# CITY of NOVI CITY COUNCIL

## Agenda Item 1 February 11, 2019

**SUBJECT:** Approval at the request of Robertson Brothers Homes, for Lakeview, JSP 18-16, with Zoning Map Amendment 18.723, to rezone from R-4 (One-Family Residential) and B-3 (General Business) to RM-2 (High Density Multiple Family Residential) subject to the related Planned Rezoning Overlay (PRO) Agreement, and corresponding PRO Concept Plan. The property is located in Sections 10 and 11, on both the west and east sides of Old Novi Road, south of Thirteen Mile Road and totals approximately 3.15 acres.

**6' ht. Screen Fence Detail**

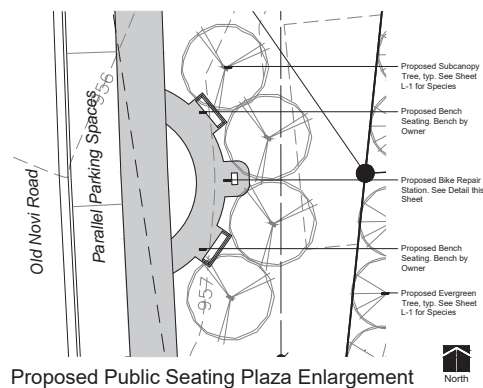
- i. Developer shall provide screening fences and/or landscaping on all portions of the Land adjacent to existing residential lots, as shown on the detail provided on Sheet L5, or comparable fences to be approved by the City's Landscape Architect. Additionally, evergreen trees, to be installed to a sufficient height as a buffer to any proposed two-story residence to be built on units 1 through 7 to be located on the Land adjacent to an existing dwelling. The required height of such trees at the time of planting shall be determined by the City at the time of final site plan review. The fences shall be installed within 8 months of issuance of a grading permit for the Development.

- No screening berm between the B-3 district and the residential properties to the south, on both sides of Old Novi Road. A 6' height vinyl screen fence is proposed in lieu of the required berm. See Sheet L-5 for Fence Detail and Sheet L-7 for Screening Sections.
- Street trees of single family homes, on all project parcels, are located in the proposed front yards, not the R.O.W.
- Landscape proposed within the R.O.W. is located within a proposed 15' width Use Easement along the west side of Old Novi Rd.

**Figure 1. City of Novi Regulated Wetland & Woodland Map** (approximate project boundary shown in red). Regulated Woodland areas are shown in green and Regulated Wetland areas are shown in blue.

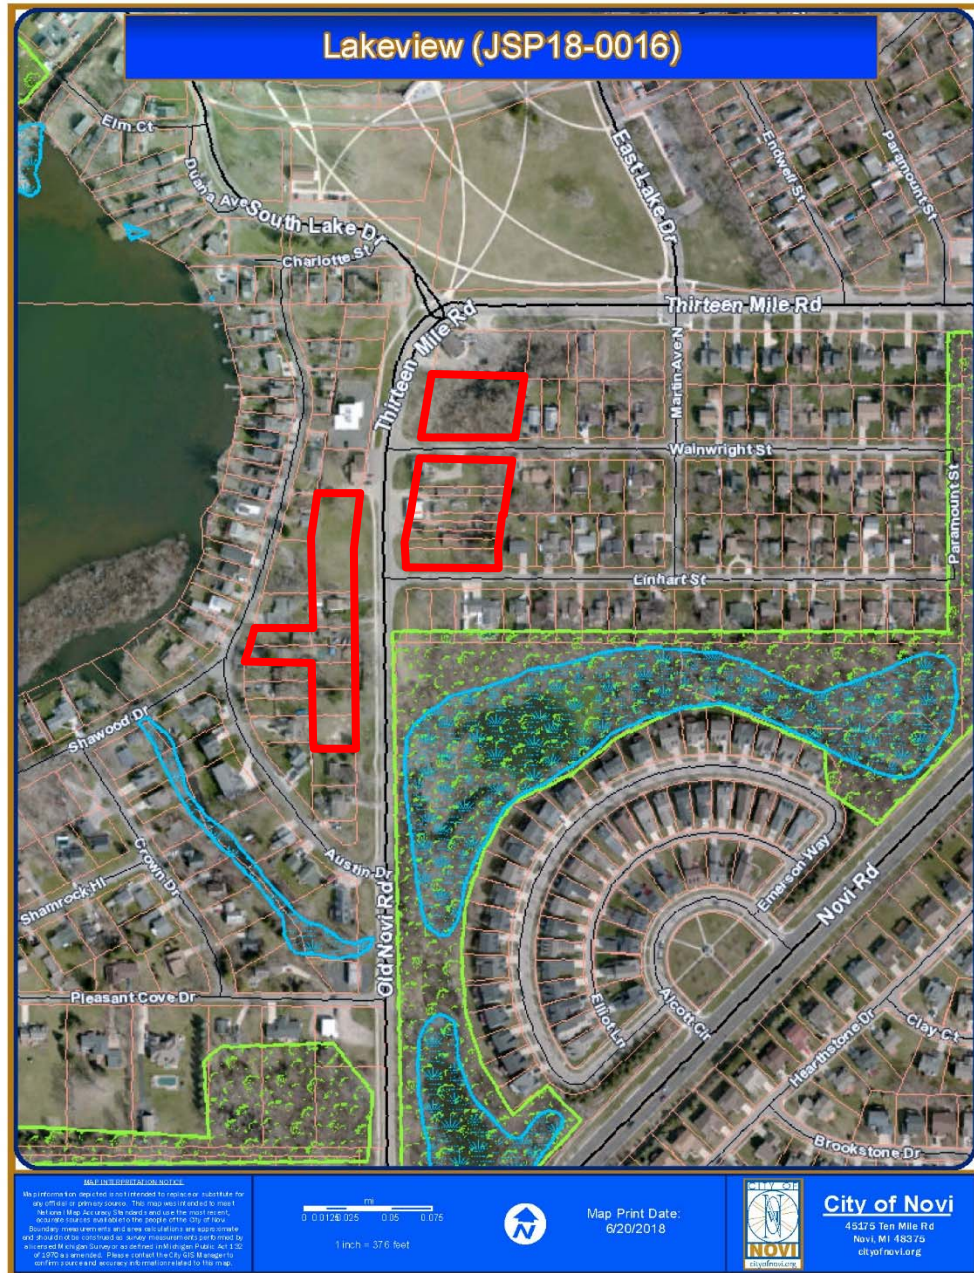
Although not indicated on the City of Novi's Regulated Wetland Map (see Figure 1), ECT identified one wetland area within the subject property at the time of the site inspection. This wetland was identified by BWA Consulting as Wetland B and wetland flag numbers are indicated as B-1 through B-14 (see Figure 2). The Plan notes that the on-site acreage of this wetland is 6,926 square feet (0.159-acre). The wetland area is an isolated forested/scrub-shrub wetland that contains an emergent depression. Vegetation observed within the wetland included silver maple (*Acer saccharinum*), cottonwood (*Populus deltoides*), box elder (*Acer negundo*), green ash (*Fraxinus pennsylvanica*), nodding beggar-ticks (*Bidens cernua*), and highbush cranberry (*Viburnum trilobum*). Surface water was present at the time of our inspection as well as water stained leaves which are an indicator of wetland hydrology. The applicant's wetland consultant noted that soils pits dug on-site revealed wetland (hydric) soils within the wetland area.
